Agenda Planning Commission July 19, 2017 7:00 PM

To: City of Plainwell Planning Commission
Date: July 14, 2017
From: Maxwell K. Dillivan, AICP
RE: **Sweetwater's Site, 554 W. Allegan Street: Site Plan**

To: City of Plainwell Planning Commission
Date: June 22, 2017
From: Maxwell K. Dillivan, AICP
RE: **Wesco #9, 551 W. Allegan Street: Site Plan**

SWEETWATER'S LANDSCAPE PLAN

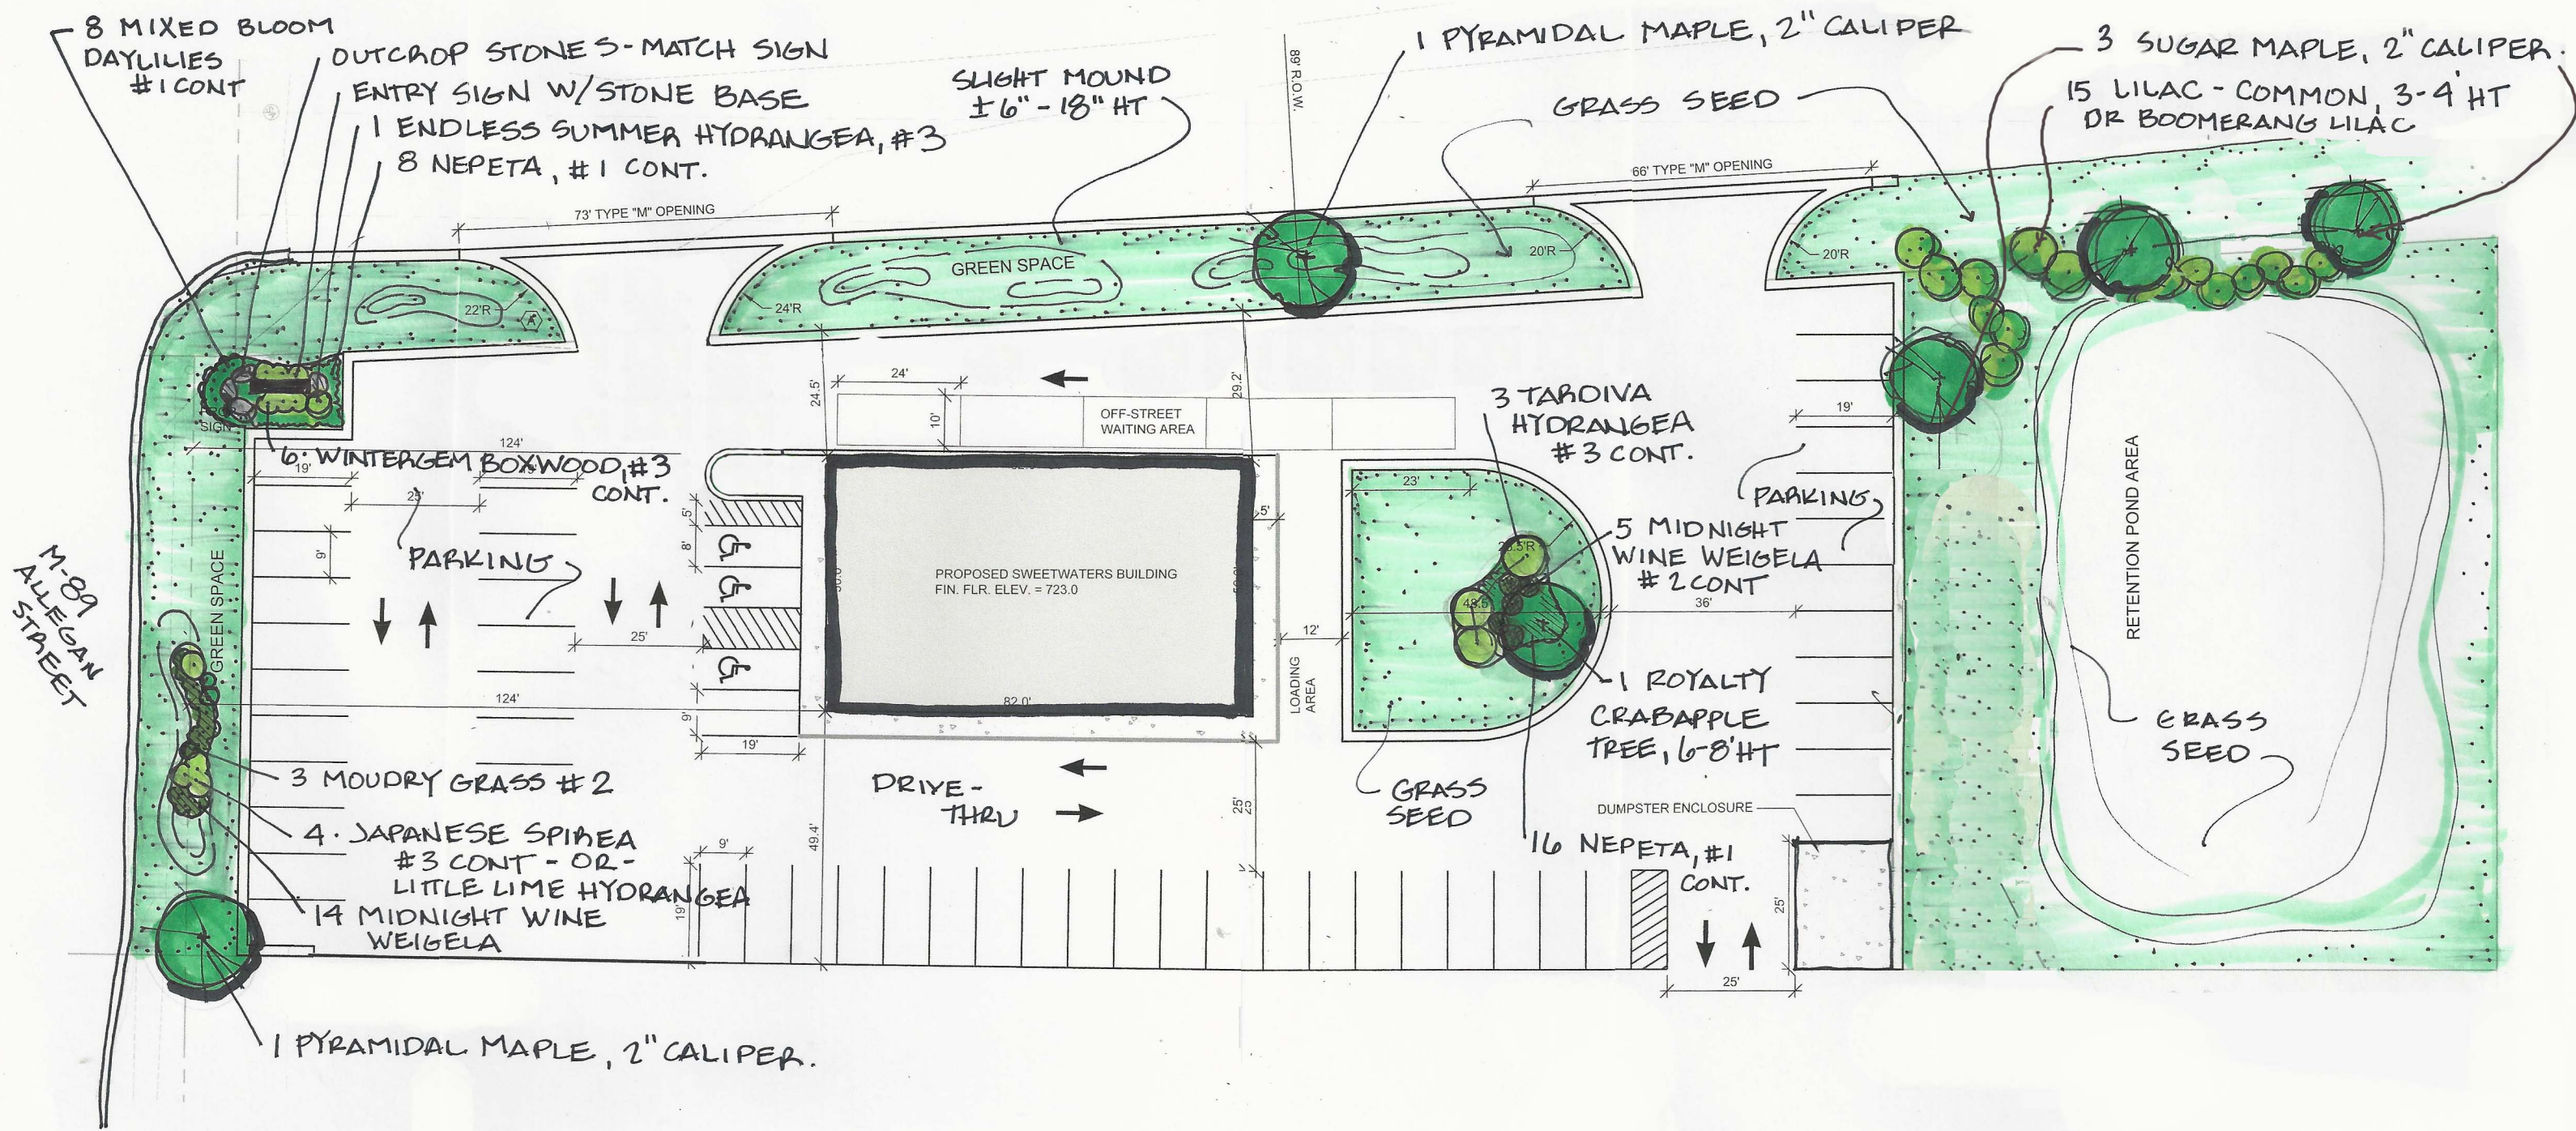
The applicant has provided a landscaping plan as part of this application. The minimum 15% of the total lot area is met (8,750 sq. ft. provided) along with one (1) required tree or shrub for every 1,000-sq. ft. of the 15% of the total area (nine (9) shrubs provided) and one (1) tree for every 1,500-sq. ft. of the 15% of the total area (six (6) trees provided). The applicant should confirm that 33% of the required landscape area (2,888 sq. ft. in total) is located between the building and the street.

1. Provide a sidewalk along the Price Street extension frontage.
2. Provide outstanding checklist items.
3. The applicant should confirm that 33% of the required landscape area (2,888 sq. ft. in total) is located between the building and the street.
4. Provide signage plan per City requirements. Confirm signage type, materials, and illumination.
5. Secure approval from the Fire Department and City Engineer.

CANOPY & FUEL DISPENSER

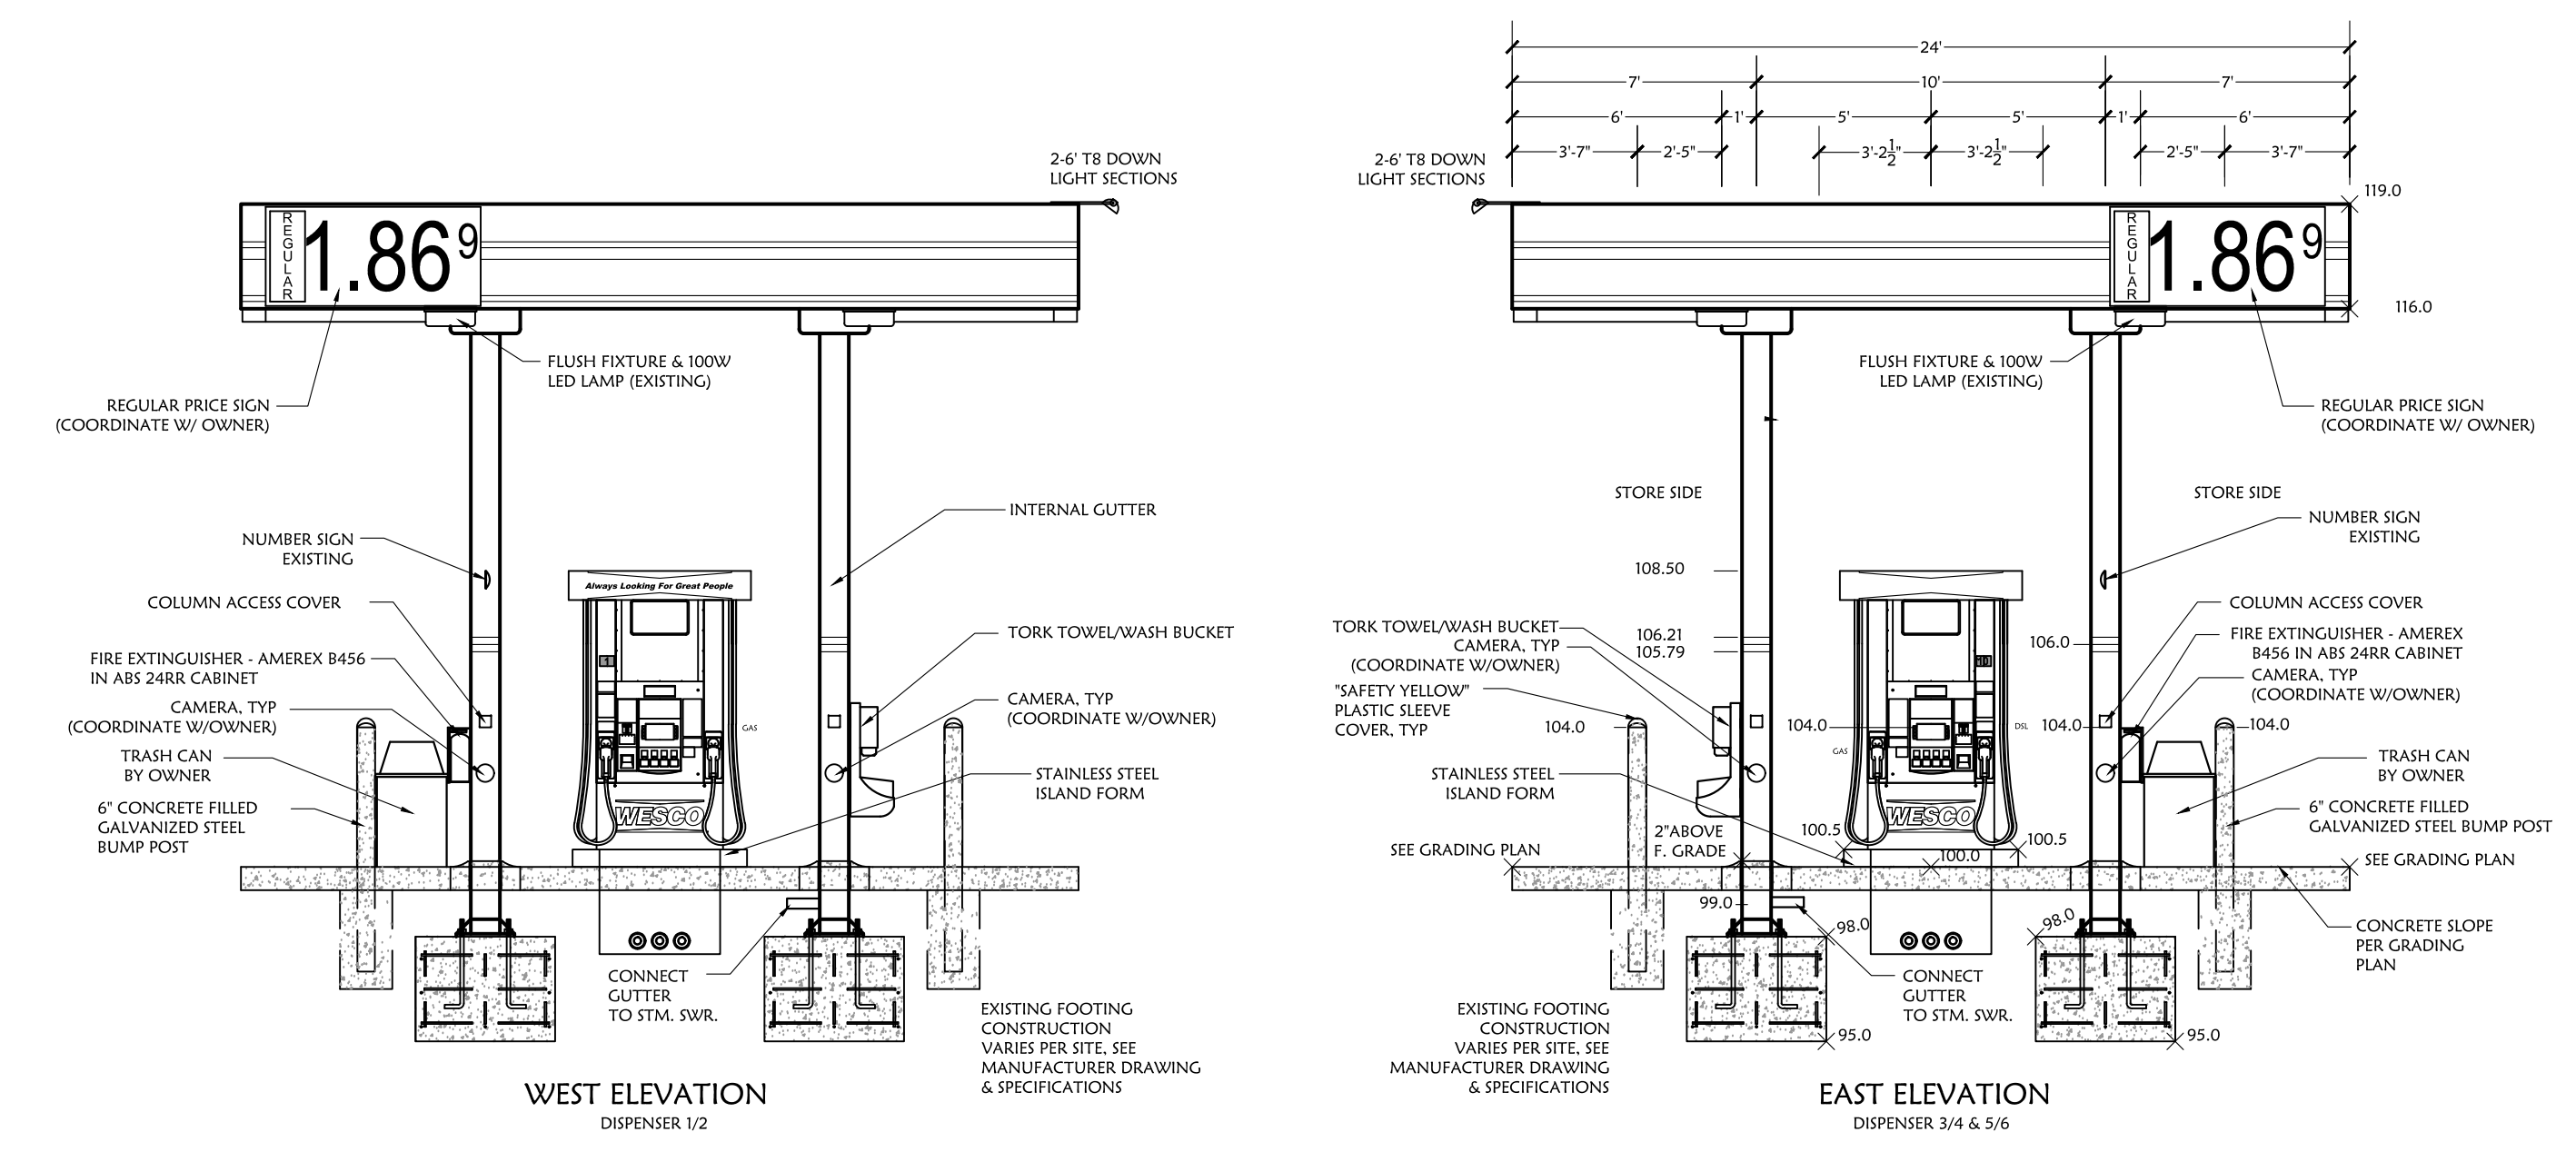
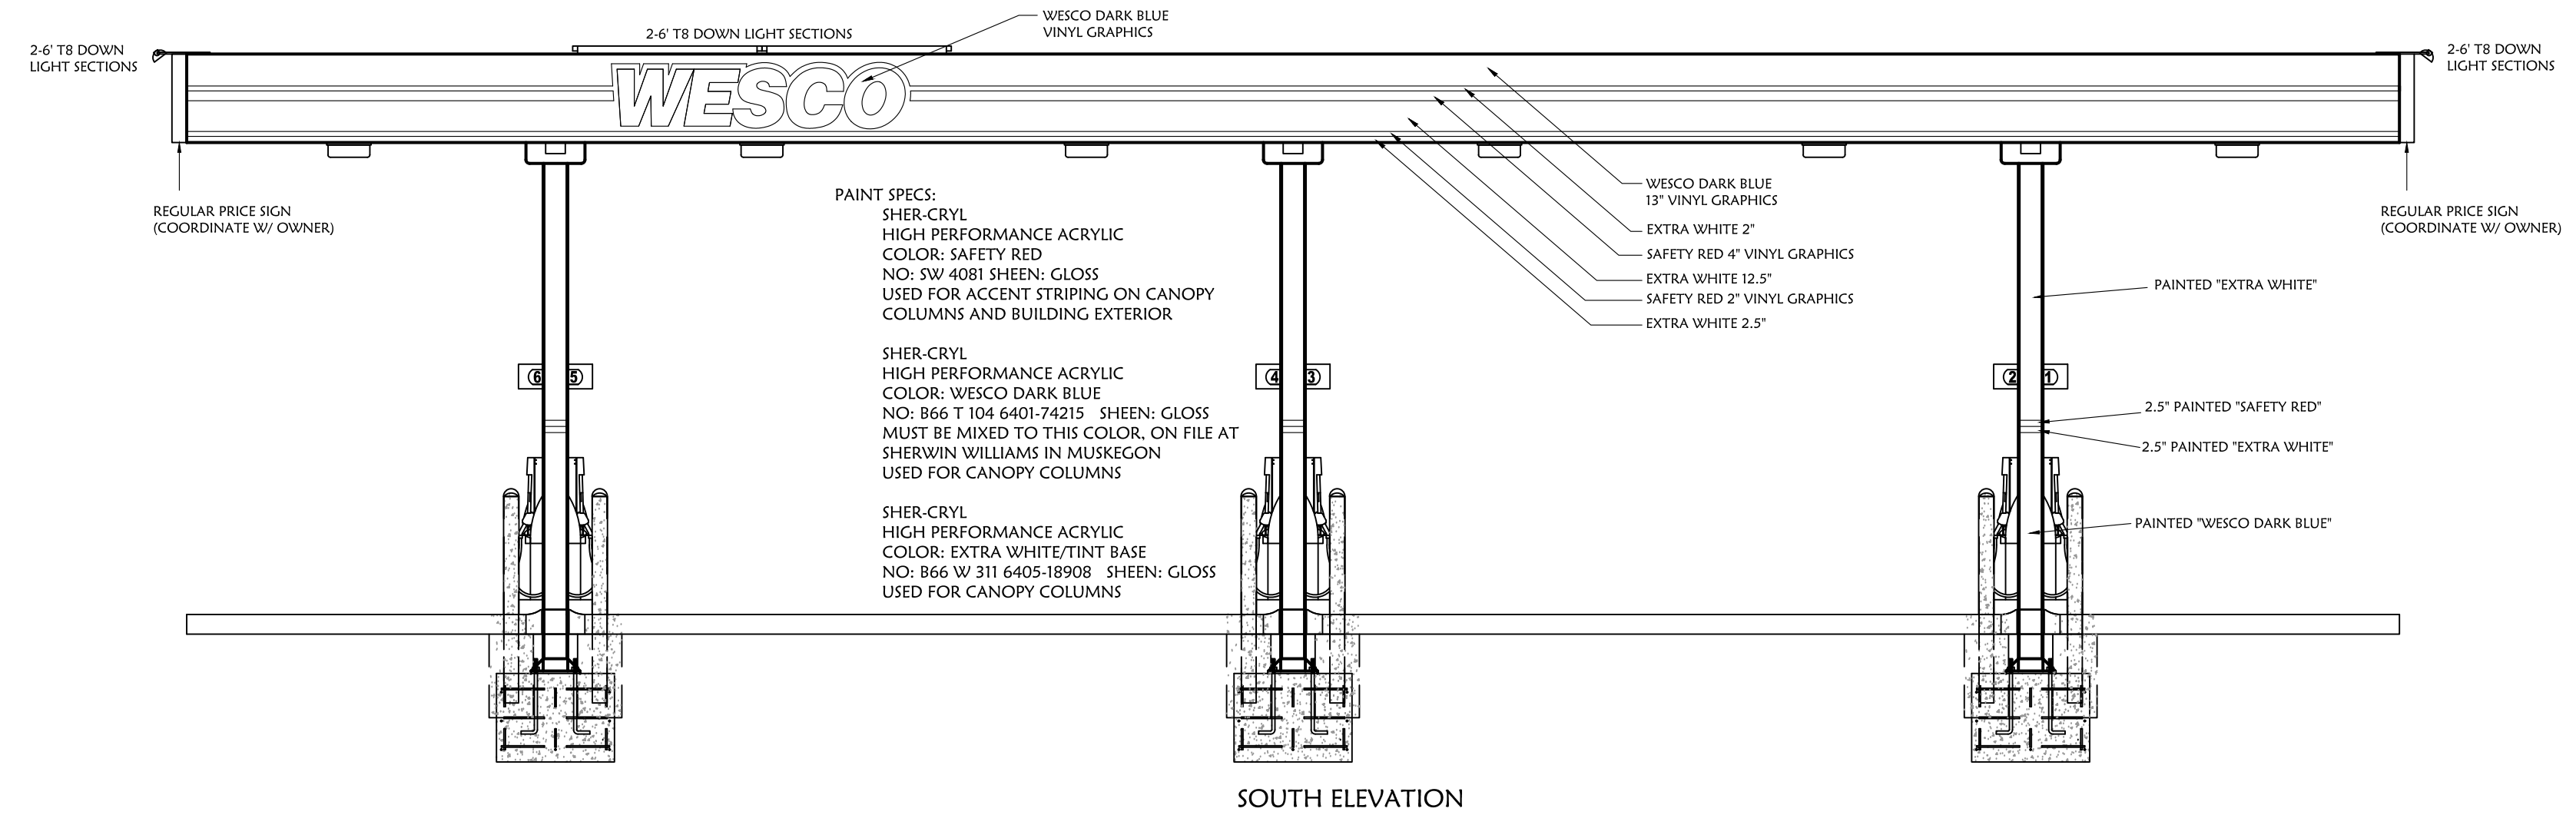
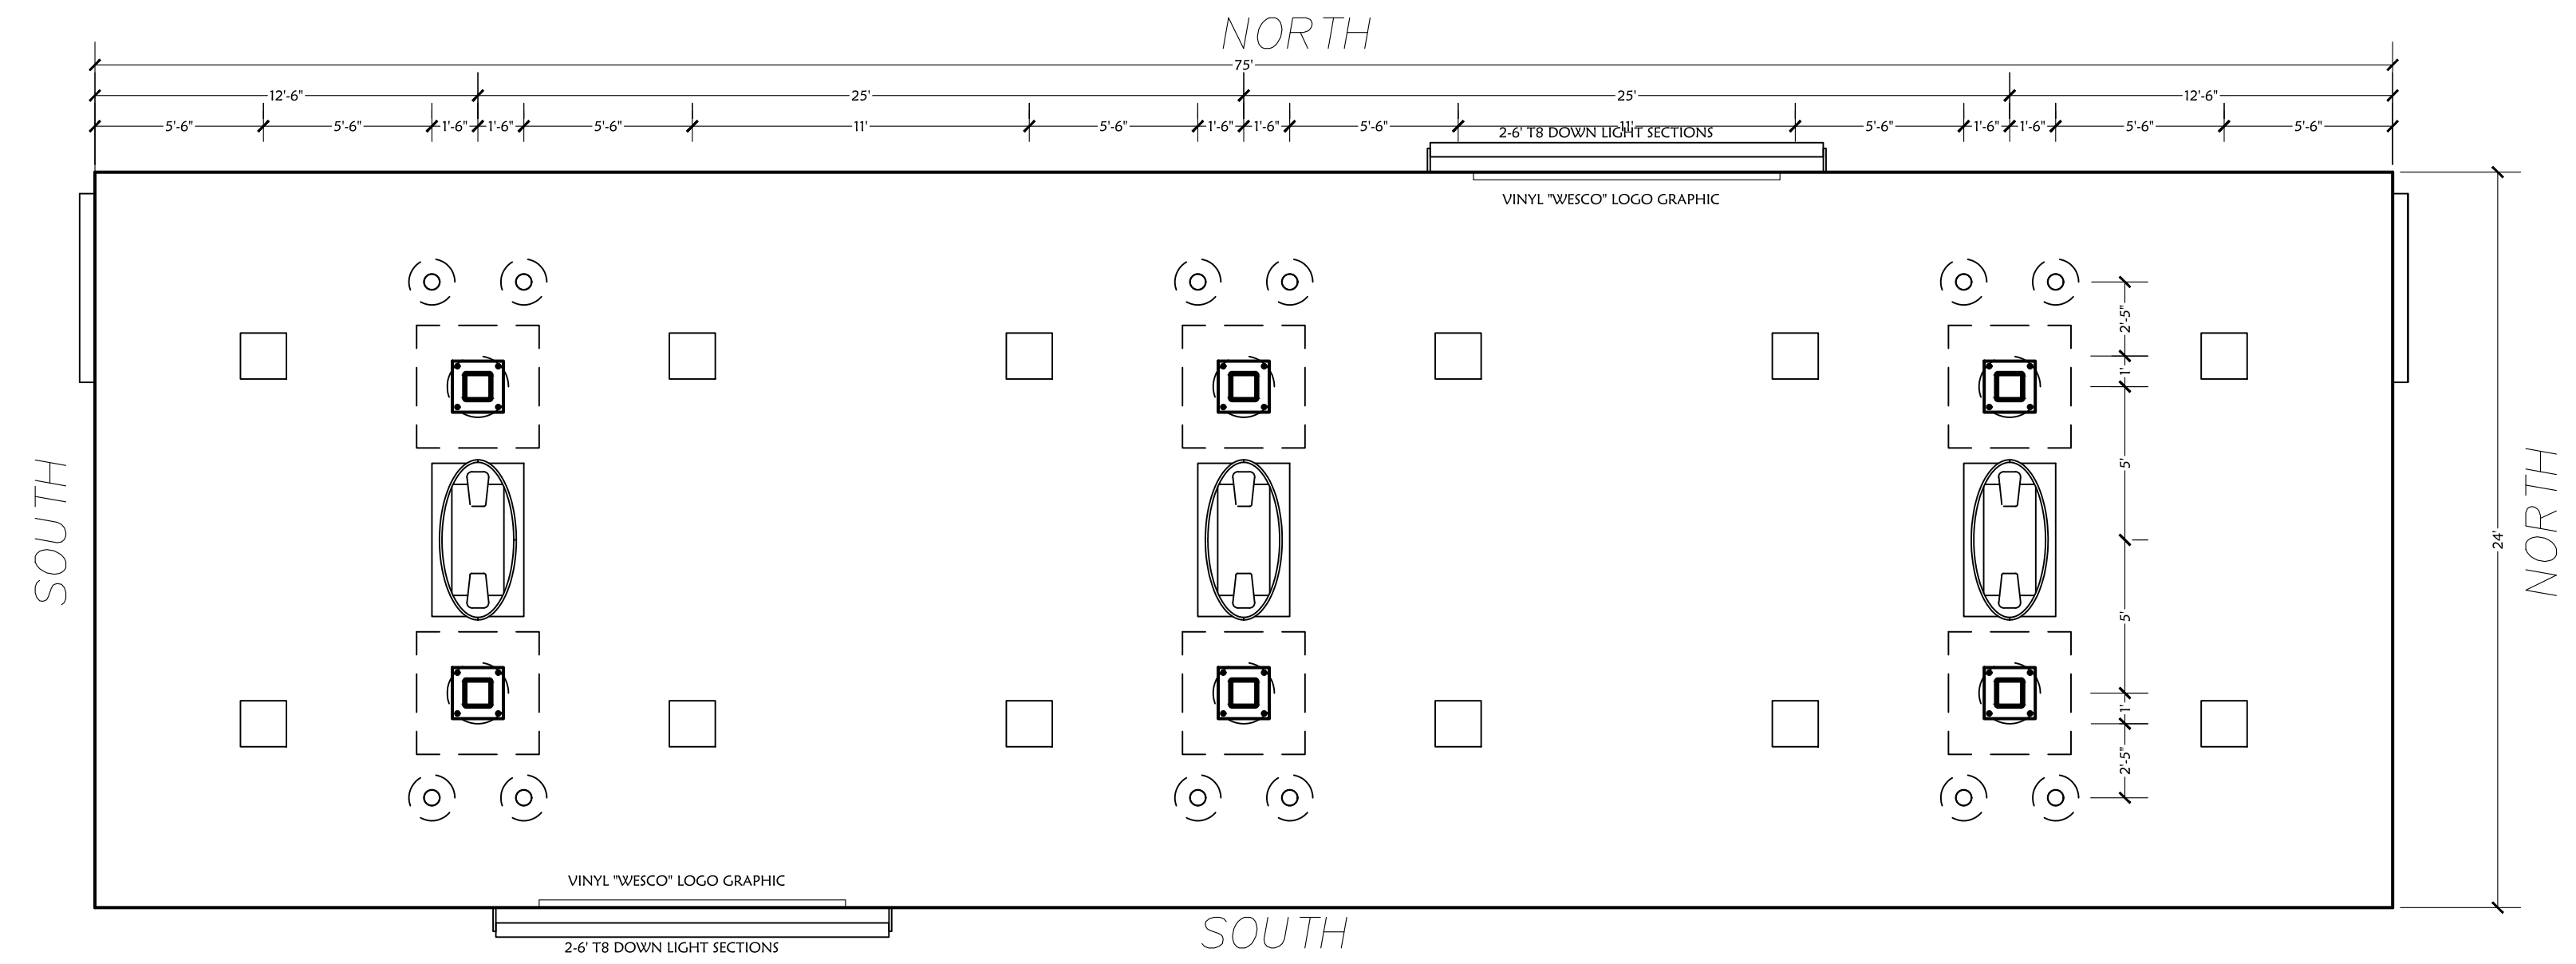
Dispenser Rebranding is noted on sheet C-502. Is that possible without replacing existing underground storage tanks? The legend on sheet G-002 shows identical graphics for existing and proposed tanks. That graphic is not apparent on sheet G-002. Sheet 1 of 1 and sheet CD-101 use the existing and proposed tank graphic. C-102 shows a proposed Triton Underground Storage Chamber. Sounds like a tank but it does not have a proposed tank graphic. Please explain what a Triton Underground Storage Chamber is. Are new gasoline storage tanks a part of this project? A cover sheet explaining the project should accompany plans that are this complicated.
